Safety Defect and Noncompliance Report Guide for Vehicles

PART 573 Defect and Noncompliance Report³

On 12-5, 2007, TRUCK EQUIPMENT SERVICE COMPANY [MFR] decided that (a defect which relates to motor vehicle safety)(a noncompliance with Federal Motor Vehicle Safety Standard No. _____) exists in the motor vehicles listed below, and is furnishing notification to the National Highway Traffic Safety Administration in accordance with 49 CFR Part 573 Defect and Noncompliance Reports.

Make(s): CORVUSKER Model Years Involved: 97-08 Model(s): 800R w/16' BOX

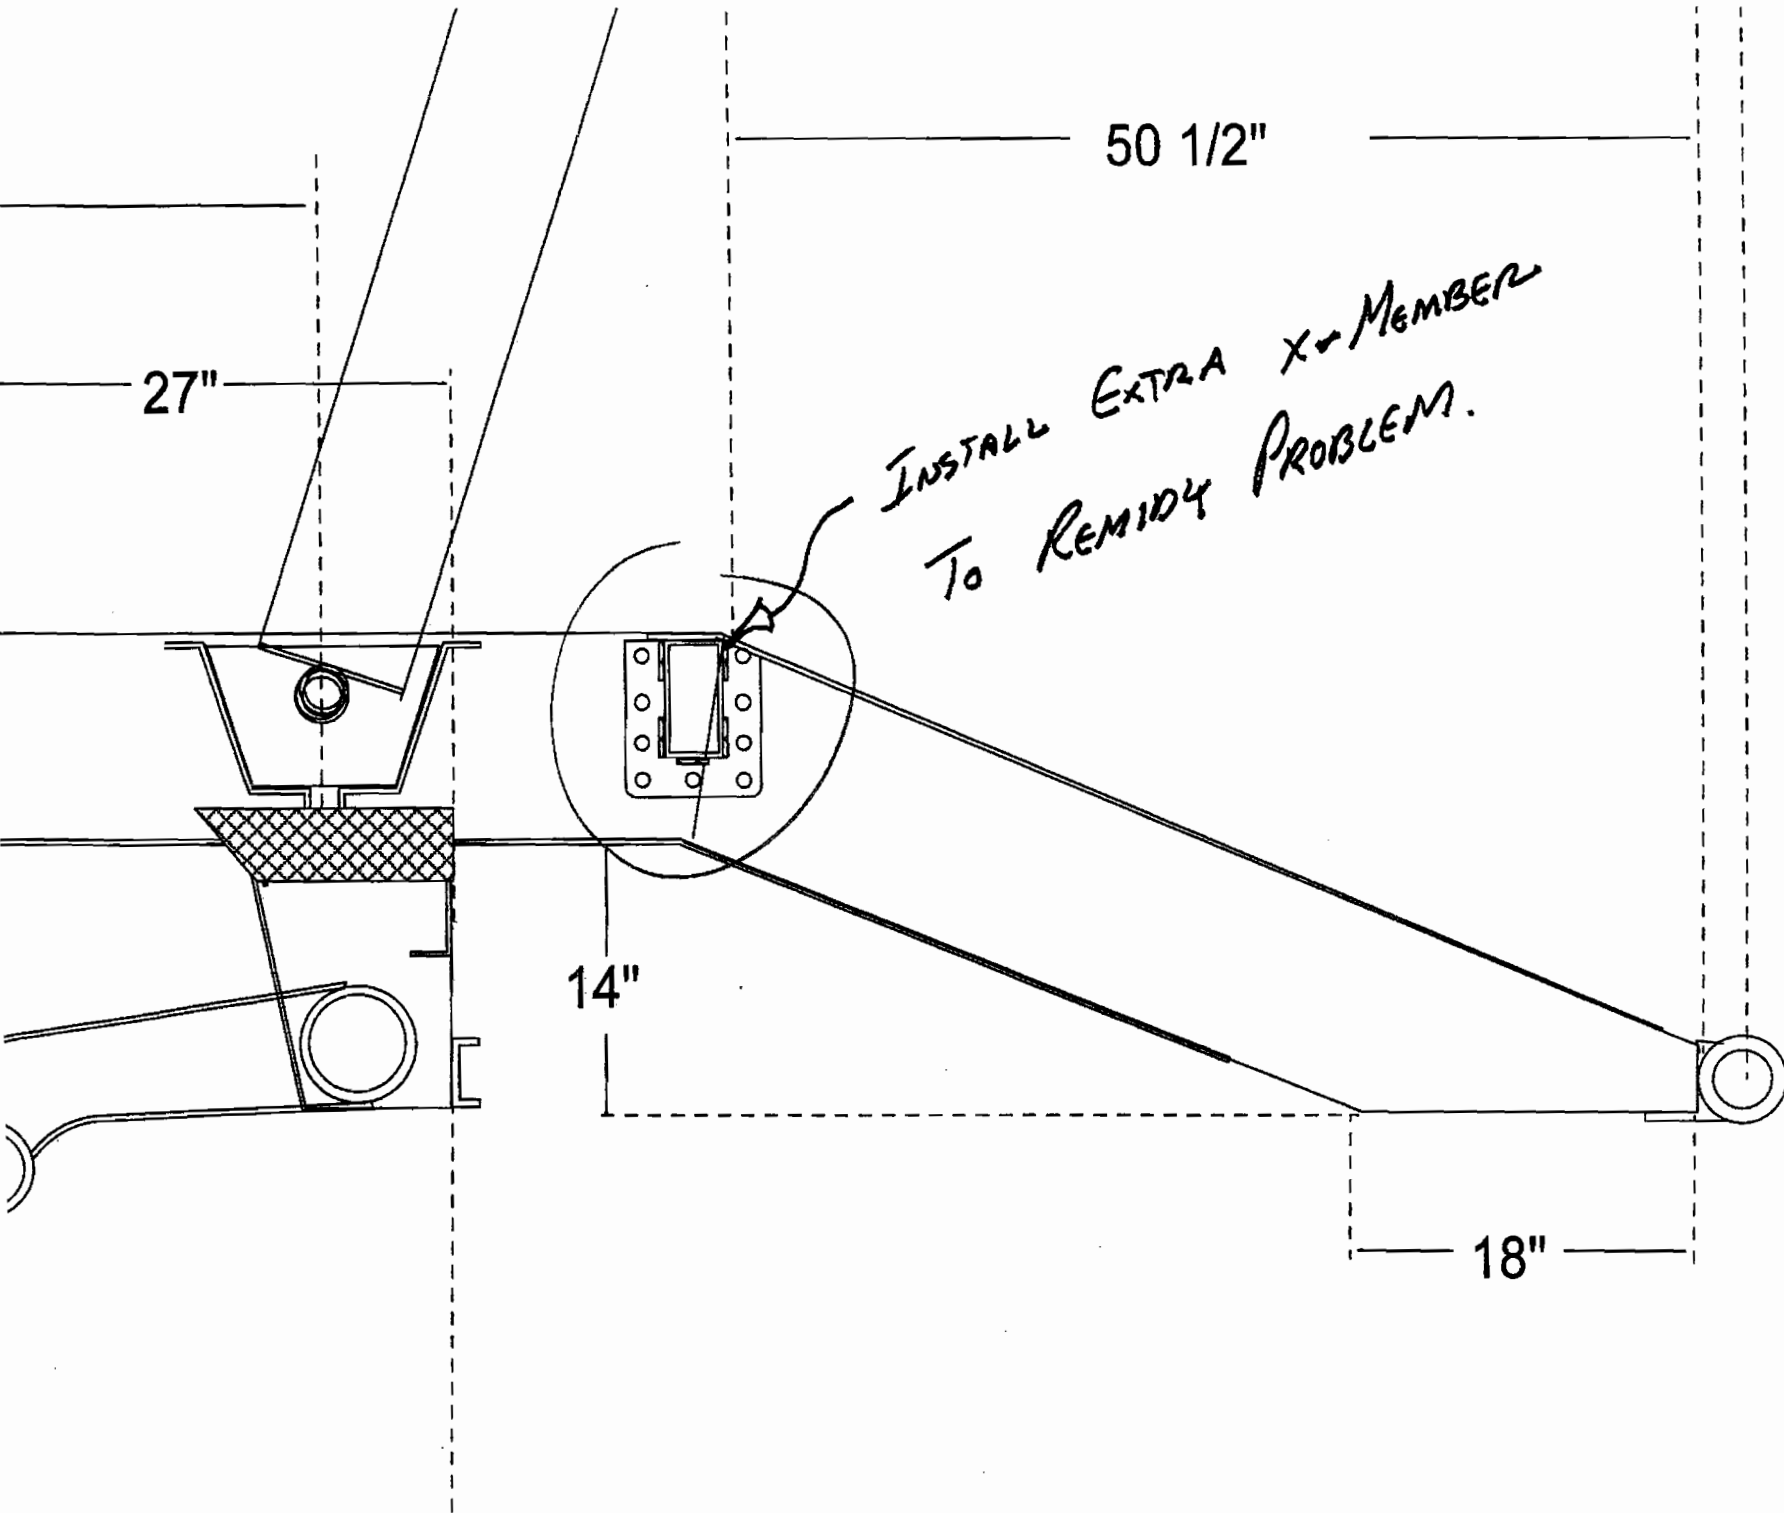
CRACKS DEVELOPE IN WELDS HOLDING THE 'NOSE'
OF THE FRAME TO THE MAIN CHASSIS

WHEN MOUNTING A 16' BOX VS. A 14' A STEEL
FRAME PLATE COVER IS SHORTENED 2'

THE CHASSIS AND BOX CAN SEPARATE FROM
THE DRAWBAR

SMALL CRACKS ARE VISIBLE ON INBOARD FRAME
RAIL WELDS

GRIND OUT AND REWELD CRACKS. INSTALL AN
EXTRA STEEL TUBULAR X-MEMBER WITH PLUG WELD
END PADS CENTERED ON THE MAIN FRAME RAIL
WELD

THE EXTRA X-MEMBER WILL STABILIZE THE WELD
AREA & REPLACE THE STRENGTH LOST WHEN THE
STEEL FRAME PLATE IS SNIPPED 2' FOR A
16' BOX MOUNT.
